Rezoning Transportation Analysis

Petition Number: 2024-006

Revision Log:

Date	Description
2-21-24	First Review (NK)
4-24-24	Second Review (NK)

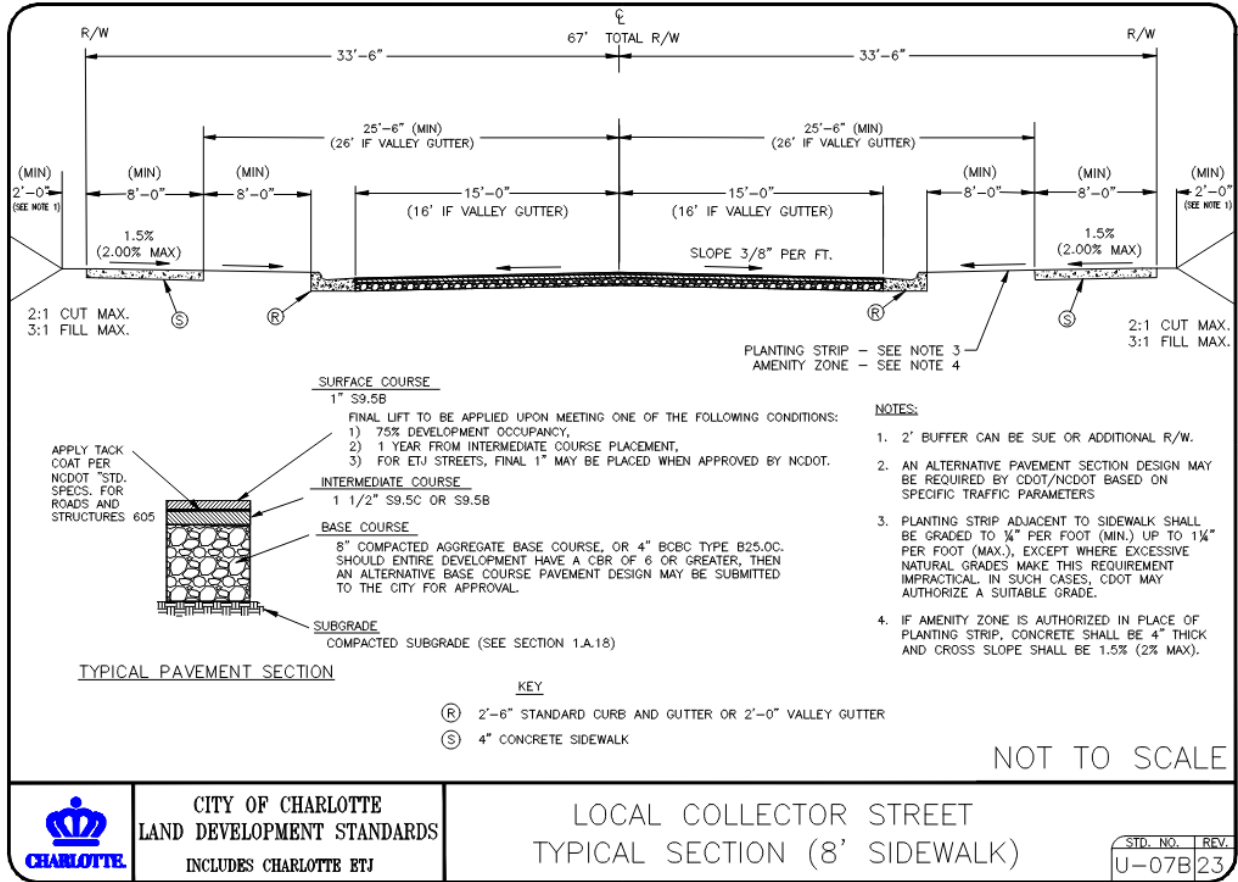
9. **New Comment 4.24.24:** Include cross section for Executive Center Drive which should follow CLDSM detail U-07B shown below:
